RE: 212 Thurston Street

I reviewed the drawings and evaluated the neighborhood context. My comments and recommendations on the design are as follows:

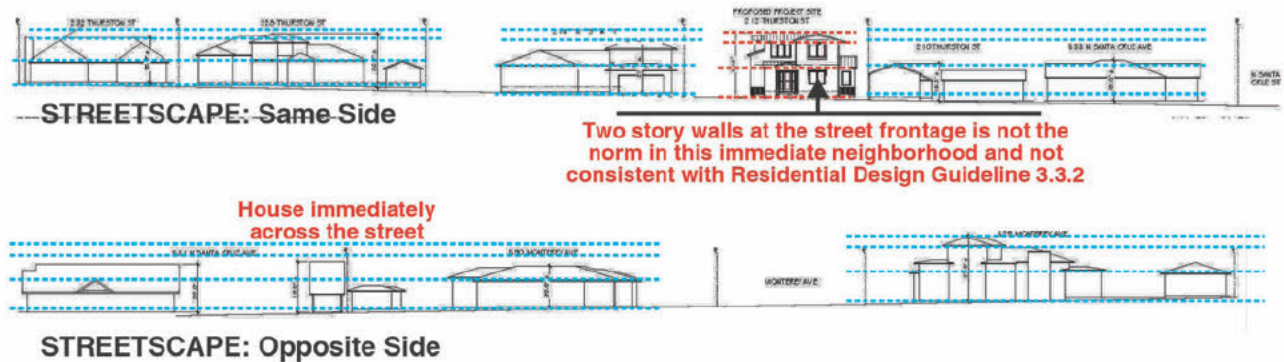
The immediate neighborhood contains a mix of one and two story homes designed in traditional styles. The proposed house, however, would be taller than many others in the immediate neighborhood - see streetscape illustration below.

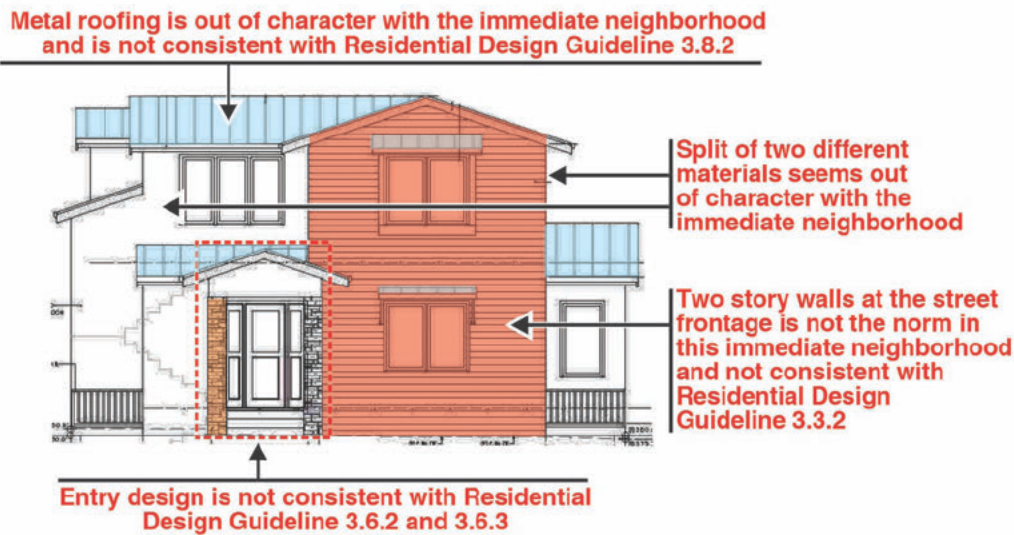
1. The two story wall at the street frontage is not the norm of the immediate neighborhood and would not be consistent with Residential Design Guideline 3.3.2.

1. Increase the size of the first floor segment over the kitchen window to reinforce the first floor eave and roof line and to improve the front facade compatibility with other homes in the immediate neighborhood.
2. Revise the entry to provide an under-the-eave entry similar to other homes in the immediate neighborhood, reinforce the first floor roof line and improve the front facade compatibility with other nearby homes.

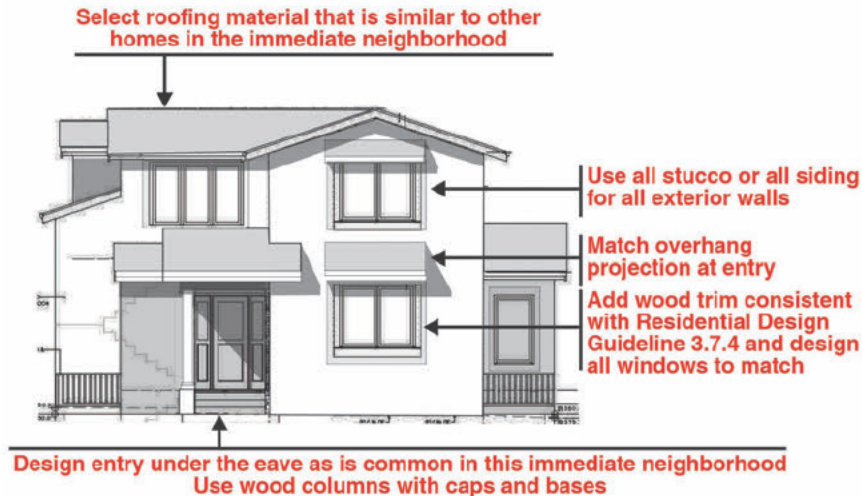
5. The stone columns at the entry are awkward and not well suited the rest of the traditional design. It would not be consistent Residential Design Guideline 3.6.2.

3. Select either stucco or horizontal siding and use it consistently on all exterior walls.
4. Select a roofing material similar to that on other homes in the immediate neighborhood.
5. Use wood columns on the front entry and back porch in lieu of the proposed stone columns.
6. Treat all windows with the same detailing and provide trim consistent with Residential Design Guideline 3.7.4.

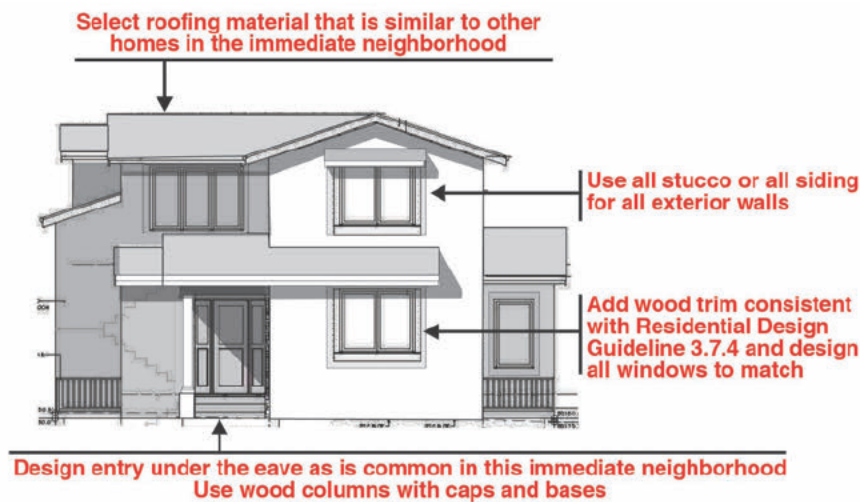
The streetscape illustrations below at a small and large scale show the proposed front elevation recommendations..

There is one other option to better relating the larger front facade to the nearby one story homes. That would be to extend the entry roof partially across the front facade in lieu of the proposed roof segment over the kitchen window. This would emphasize the one story eave portion of the home.
